#### REMARKS

### **CORRECTION OF THE DRAWINGS**

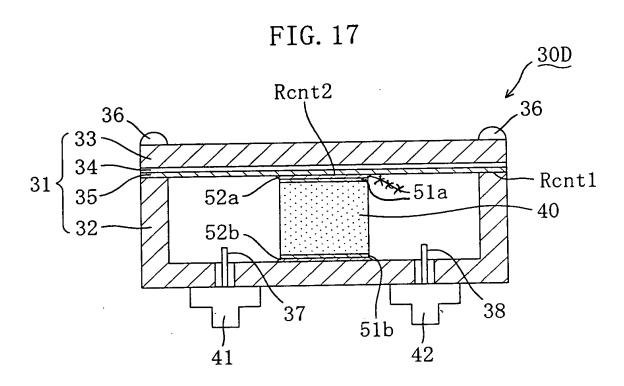
In the Office Action of July 24, 2002 (and reiterated in the Office Action of January 24, 2003) the Examiner objected to the drawings and has requested the Applicant to supply proposed corrections. Accordingly, submitted herewith are proposed corrections to Figures 17 and 20. With regard to Figure 17, the Examiner objected for the reason that reference number 52a does not appear to be included in the specification at page 47. Upon review, Applicants respectfully note that, in fact, reference numeral 52a does appear in the specification at line 13, although that reference numeral was not shown in bold print as were the other reference numerals on that page.

However, in reviewing Figure 17, it does, nevertheless, appear that Figure 17 needs to be corrected, because the lead lines for numbers 52a and 51a appear to be pointing to the same structure. As made clear in the specification, solder (52a) is used to mechanically and electrically couple the dielectric 40 with the metallized layer 51a. Thus, the lead line for reference numeral 51a has been corrected to indicate the metallized layer in conformity with the description contained in the specification.

With regard to Figure 20, the Examiner has noted that reference numeral 36 should instead read reference numeral 535. This has been corrected.
